KOOGLER & ASSOCIATES
ENVIRONMENTAL SERVICES

Subject: Florida Mining Corporation – Mabel Cement Plant
Response to Request for Additional Information dated June 24, 2005
DEP File No. 1190040-001-AC (PSD-FL-356)

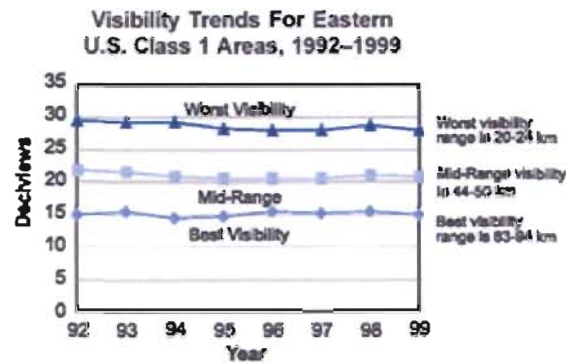
24. A very cursory assessment was provided pursuant to Paragraph 62-212.400(h)5., F.A.C. The rule requires information relating to the air quality impacts of, and the nature and extent of, all general commercial, residential, industrial and other growth which has occurred since August 7, 1977, in the area the facility or modification would affect. While the applicant believes the largest area is a 3 kilometer radius, the Department believes the radius arguably includes the entire county and possibly the contiguous counties. The impacts include visibility impairment and effects on regional ozone concentrations. Please expand the write-up to include development in Sumter and surrounding counties as well as ambient air quality trends in and near Sumter County.

Visibility impairment¹ can be estimated from the following maps.

Although the entire US is portrayed, it can be seen that visibility impairment in the central Florida area increased in 1980 relative to 1970, and then decreased in 1990 to the same approximate level as 1970.

FIGURE 1-8. EXACT AND APPROXIMATE REPRESENTATIONS OF A LINE SOURCE BY MULTIPLE VOLUME SOURCES

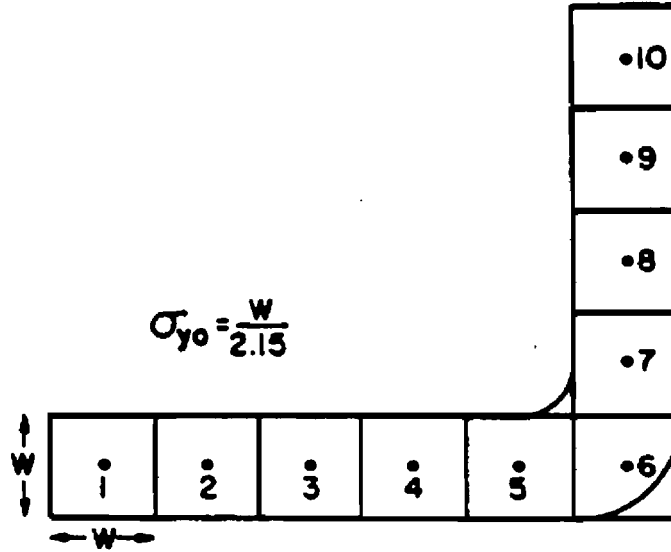
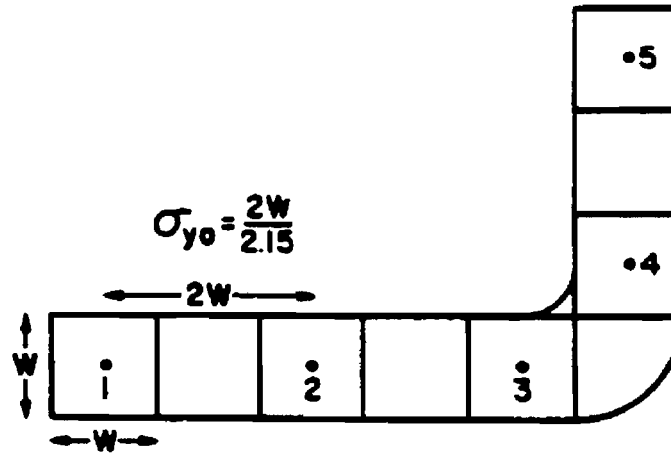
25. Please provide a detailed discussion of the truck traffic that will be generated from the construction and operation of the kiln. Some of this information has already been provided on your spreadsheets describing the road sources. Please show where the values of 6.8 for init lat and 1.84 for init vert came from in your spreadsheet describing the paved roads emissions estimation. Please discuss how the release height of 0 meters was chosen. Please provide a diagram showing each road segment, its location and its emission parameters.

For this project, the roadway width is 24 feet. The dimensions of each volume source are therefore 24 feet by 24 feet (7.31 m x 7.31 m). The roadway was modeled using an approximate representation of a line source by multiple separated volume sources. As shown below in Figure 1-8, the spacing between the separated volume sources is twice the width of each volume source (14.63 m).

The initial lateral dimensions (init lat) for a line source represented by separated volume sources (see Figure 1-8(b)) is determined by dividing the center to center distance by 2.15.

The initial vertical dimensions (init vert) for a surface-based source (release height = 0 m) is determined by dividing the vertical dimension of source by 2.15. The vertical dimension of each volume source is the height of the trucks, assumed as 13 feet (3.96 m).
